13.1 SCOPE

13.2 DEFINITIONS

Figure A13.4.3.1-1 Effective Length of Cantilever for Carrying Concentrated Post Loads, Transverse or Vertical.

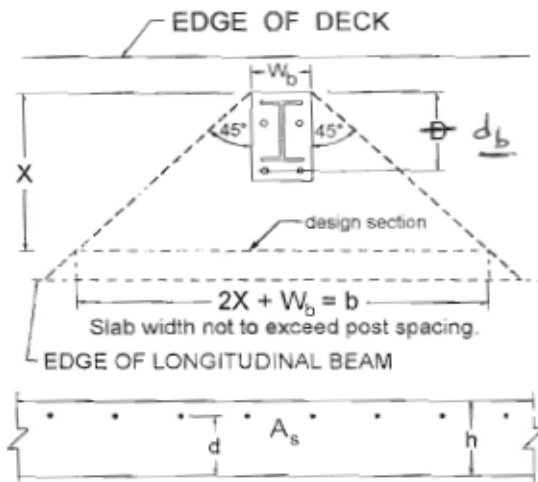
A13.4.3.1 Overhang Design

Revise as follows:

where:

M_{post} = ~~flexural resistance of railing post (kips)~~
plastic moment resistance of a single post
(kip-ft.)

P_p = ~~shear corresponding to M_{post} (kips)~~ shear
force on a single post which corresponds to
 M_{post} and is located \bar{Y} above the deck (kips)

X = distance from the outside edge of the post base plate to the section under investigation, as specified in Figure 1 (ft.)

W_b = width of base plate (ft.)

\bar{d}_b = distance from the outer edge of the base plate to the innermost row of bolts, as shown in Figure 1 (ft.)
